Transport Note

Project MMU Library Transformation Project
Subject Response to Transport Comments on Planning Application
Project no 053621
Date 31 January 2024

Figure 2: Cycle Parking Locations in the Vicinity of the Library

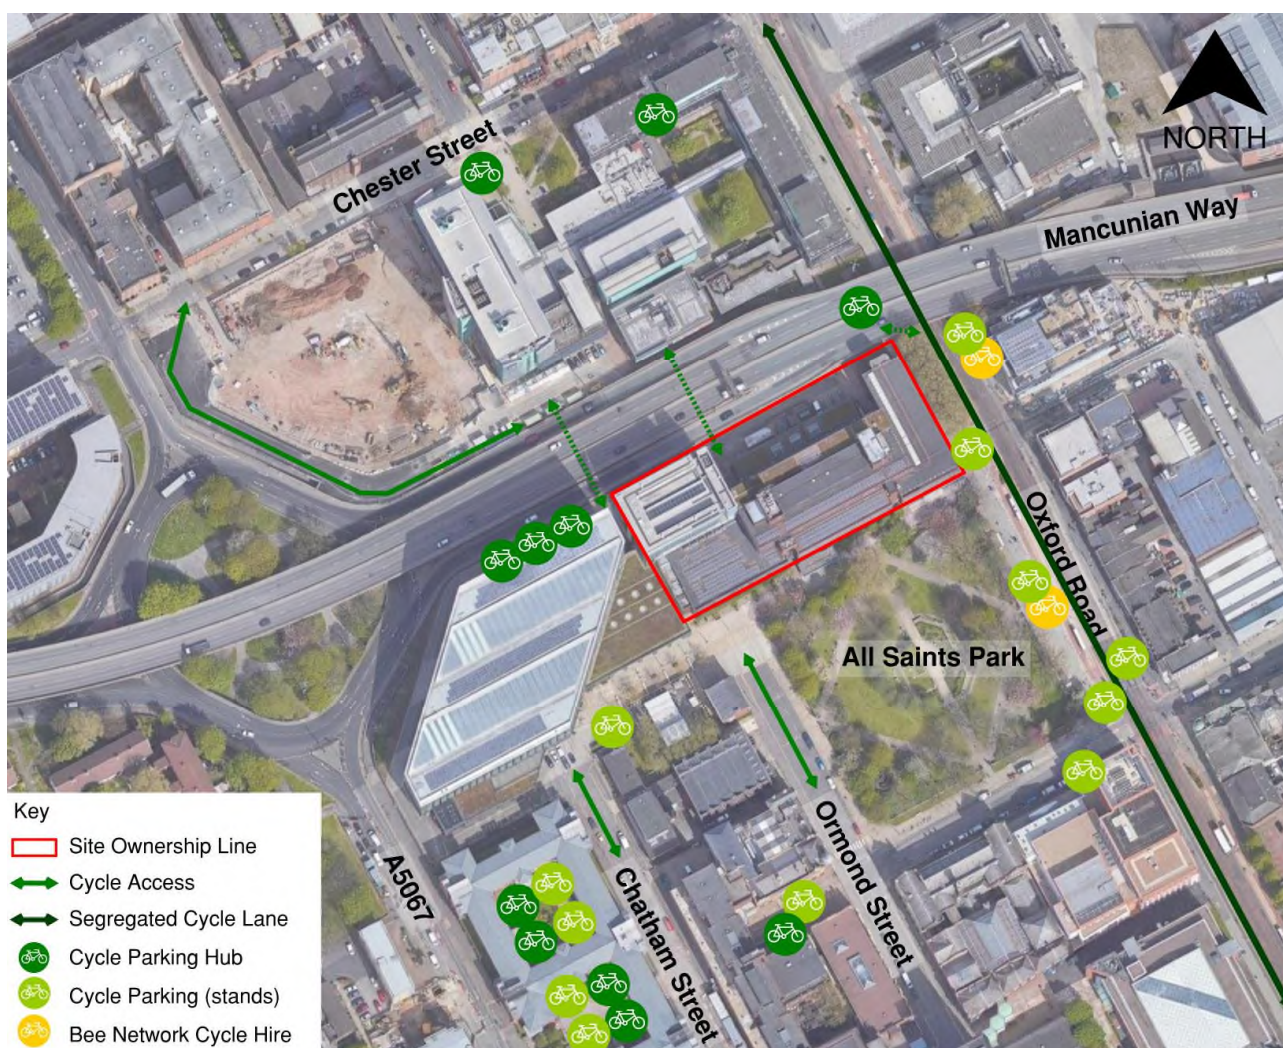
"No additional cycle parking is proposed as part of the development. The TS makes reference to various existing cycle parking provisions within the vicinity of the site including public/short-stay provision and sheltered/secure provision off the northern service access road and beneath Mancunian Way. Highways request that an assessment of existing/future short/-long-stay cycle parking provision/capacity is submitted in order to understand whether additional cycle parking provision would be required to cater for the proposed redevelopment. Highways also request clarification on the access arrangements for those withing to gain access to the secure provision beneath Mancunian Way.

Details of the usage of the cycle parking should be provided to understand how attractive and safe it is currently to the users of the cycle parking. Sheffield stands for cycle parking are not suitable and more secure cycle parking is required."

In terms of the provision and utilisation of spaces, Figure 2 below shows the location of cycle parking in the vicinity of the site. Table 2 provides the detail of the cycle parking provision in terms of numbers of stands and spaces, as well as the occupancy observed during the Travel Plan audit in January 2023. It is also noted that the All Saints Public Realm scheme (planning reference: 128485/FO/2020) to the south of the library includes the provision of an additional 14 cycle stands, which will provide 28 cycle parking spaces. The existing 4 Sheffield stands on Oxford Road (east of the library) are proposed to be retained.

Access to the secure cycle parking under Mancunian Way is not proposed to be changed as a result of the proposed development. The cycle parking is accessed off Oxford Road via a secure lockable gate, as shown in Figure 3 below. Students and staff wishing to park their bike there are required to register to obtain an access code.

In response to MCC's concerns about cycle parking provision and utilisation of spaces, it is suggested that a suitably worded planning condition be agreed to ensure that this is monitored in future as part of the regular Travel Plan updates. The scope of this monitoring would be agreed with MMU and would include the monitoring of cycle parking provision and utilisation of spaces throughout the MMU campus by MMU.
